Work Order ID 138183

Item Name: Quick Release Basket and Long Cargo Tube Mounting Provisions, Fits LH or RH

DART SERVICE INSTRUCTION

TO AMEND INSTALLATION INSTRUCTIONS D350-607-3 Rev.D,
INSTALLATION INSTRUCTIONS D350-607-4 Rev. C AND
INSTRUCTIONS FOR CONTINUED AIRWORTHINESS ICA-D350-607 REV. 6
REF TCCA STC: SH94-14
REF FAA STC: SR00213NY
REF EASA STC: EASA.10016996
REF BRAZILIAN STC: 2007S03-03/-04/-05/-06

FIGURE 1: INSTALLATION OF D4775-041 FWD STRUT

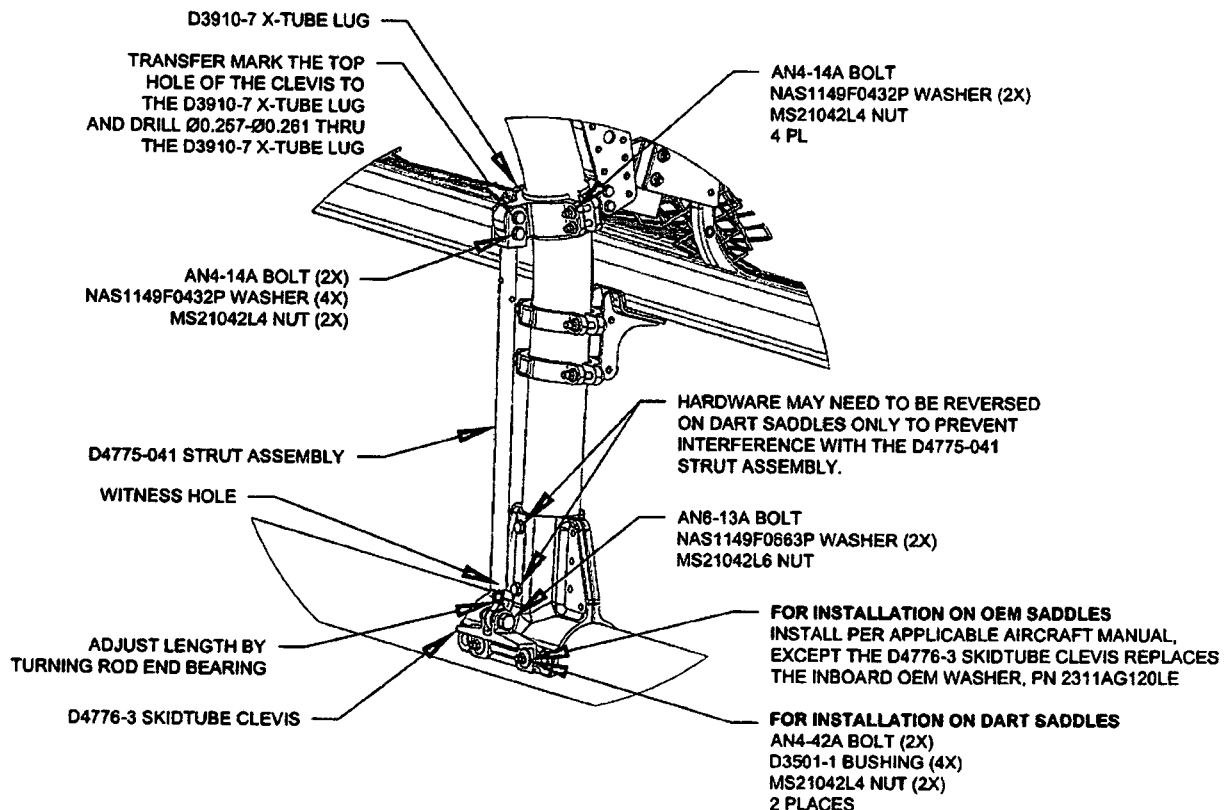
- 3.1 Substitute the Forward Lower D3910-5 X-Tube Lug with the D3910-7 X-Tube Lug as shown in Figure 1.
- 3.2 Install the forward D4775-041 Strut Assembly. Transfer mark from the upper hole on the clevis of the D4775-041 Strut Assembly to the D3910-7 X-tube Lug and drill thru the lug $\varnothing 0.257 - \varnothing 0.261$ as shown in Figure 1. Touch up chemical conversion coating per MIL-DTL-5541. Check the witness holes located at the bottom end of the D4775-041 Strut Assemblies to ensure that the thread from the rod end extends past the witness hole.
Torque MS21042L4/-4 nuts to 50-70 in-lbs (5.7-7.9 N-m). Torque MS21042L6/-6 nuts to 160-190 in-lbs (18.1-21.5 N-m).
- 3.3 Complete the installation in accordance with Installation Instructions D350-607-3 Rev. D or D350-607-4 Rev. C.
